Haesong Corporation Limited

Haesong Sweater Ltd.

Hizalhati (Baroipara), Kaliakair, Gazipur, Bangladesh
(24.027194N, 90.23911123E)

30 October 2013

Cracking on beams

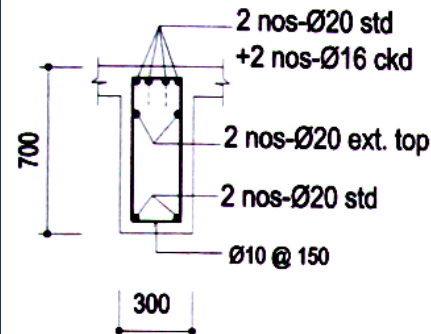
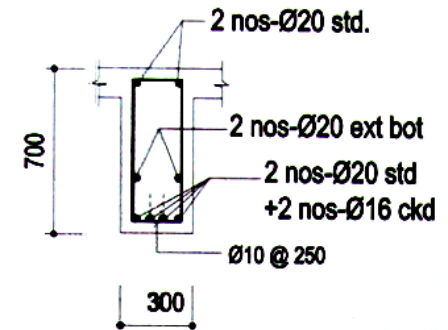
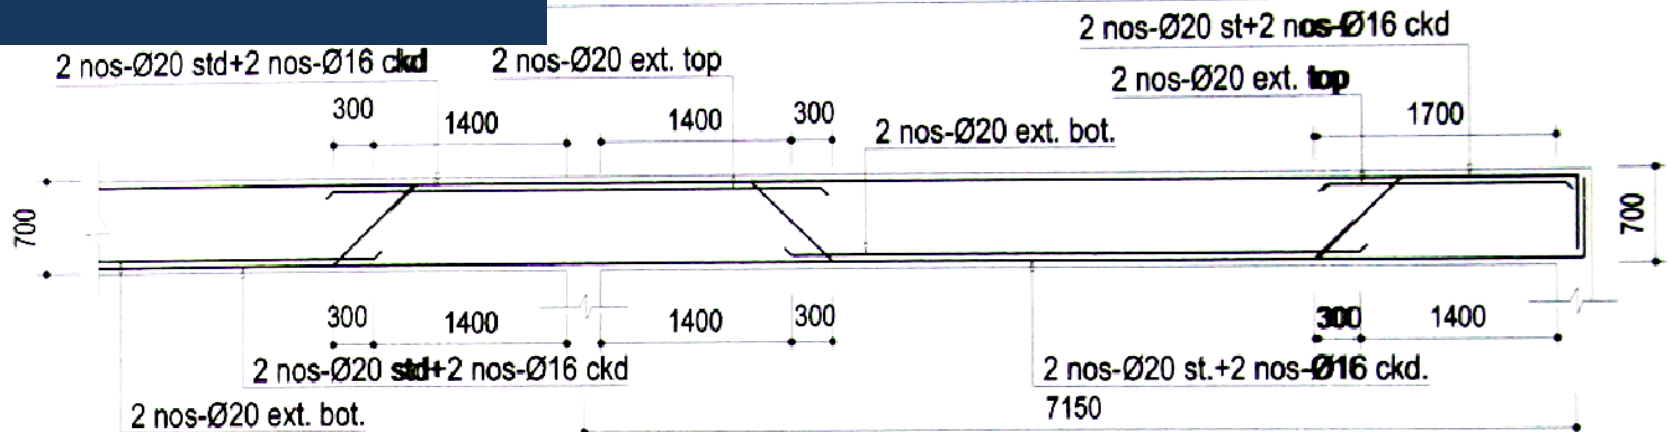
Numerous beams in the building have shrinkage cracks, Upper floors beams are more cracked. Cause to be investigated.

Appears that lack of side reinforcement bar on deep beams missing(700x280)

Cracks appear be bigger that they are due to paint is lost both sides of crack.

Lack of side reinforcement
on deep beams
(700x280)

To be investigated

Item No.	Observation	Recommended Action Plan	Recommended Timeline
13	Broken parapet on roof top corner	Cracks have been produced by deflection of the cantilever slab . Building's Engineer must specify a masonry repair system to fix parapet pieces currently separated by cracks.	6-months
14	Roof Top Garden overloading of roof slab	Limit earth layer thickness to 18 cm. Building's Engineer to ensure adequate water proofing system has been located under the orchard	6-months
15	Deflections on slabs produce rain water accumulation on a non well sloped roof	Manage drainage from roof level and downpipes to avoid structural corrosion due to continuous moisture. Avoid overloading from casting heavy sloped layer on top of the structural slab. Lightweight system required.	6-months

Broken parapet

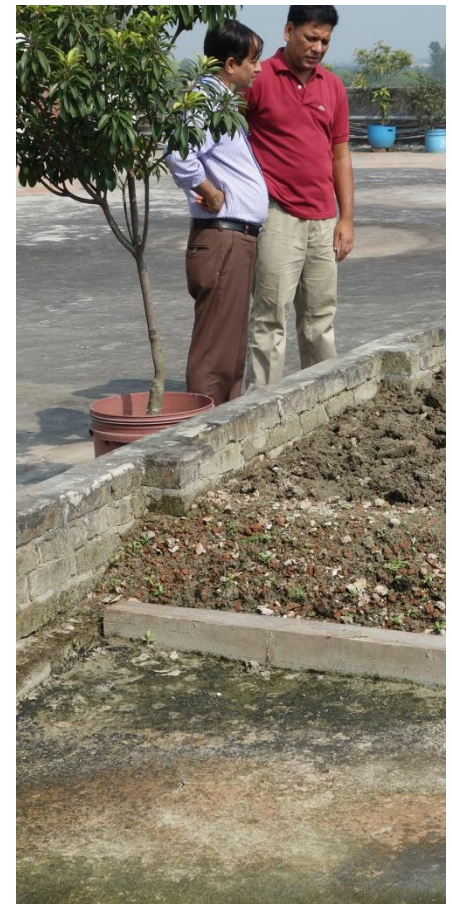
Masonry parapet laying on a cantilever slab. Crack produced by slab deflection.

Currently the cantilever slab is overloaded by a mound of earth. It must be removed

Item No.	Observation	Recommended Action Plan	Recommended Timeline
10	Concrete strength in columns within 5 storeys area - Verify concrete strengths on internal columns supporting 5 storeys at GF	Produce and actively manage a loading plan for all floor plates within the factory giving consideration to floor capacity and column capacity.	6-months
11	Shrinkage cracking on all beams	Shrinkage cracks need to be sealed against water entry and moisture to prevent corrosion. Building's Engineer must specify a sealant system. Common repair methods include chipping out the crack and applying a mortar patching compound to the surface, use of epoxies, or other sealants.	6-months
12	Broken parapet on roof top corner	Remove mound of earth from roof corner which is overloading the cantilever.	6-weeks

Slabs deflection

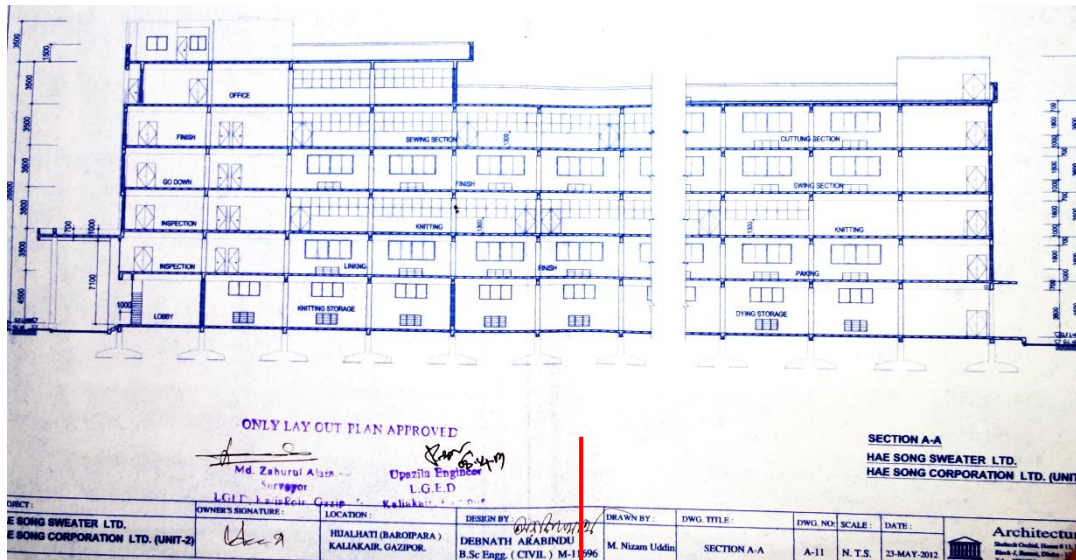
No drainage flat roof
Rain water accumulation on deflected slabs between beams may produce damage and corrosion.

Inadequate sloped layer on top of the structural slab or non sloped slab.

Down pipes are on long facades, then drainage slope might be in that direction (transversal slope)

Steel Bracing

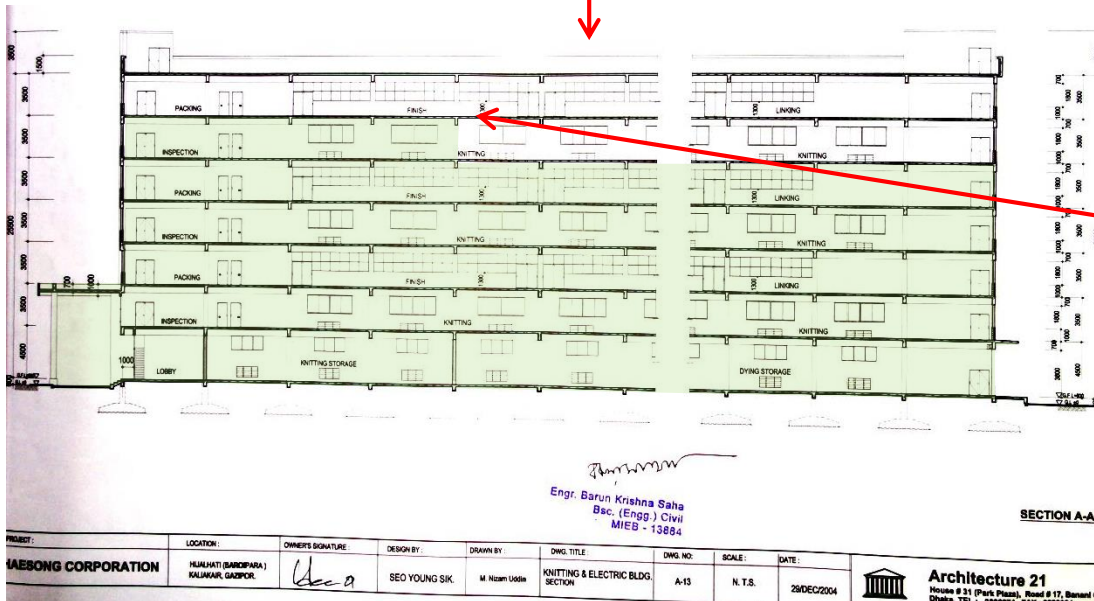
Structure supporting cooling water tank for generator on Generator building roof has an inadequate bracing system.

Lateral bracing system uncompleted It does not get footings.

Vertical bracing in the perpendicular direction is missing.

Item No.	Observation	Recommended Action Plan	Recommended Timeline
16	Inappropriate bracing system on generator cooling water tank structure.	Building engineer to carry out a stability analysis of the water tank structure and propose additional stability system.	6-months
17	Structural drawings do not agree with current arrangement of the building at roof top	The structural drawings showed inconsistencies compared to the current structure observed on site at roof. We suggest a professional structural engineer verifies the current design and corrects these drawings.	6-months
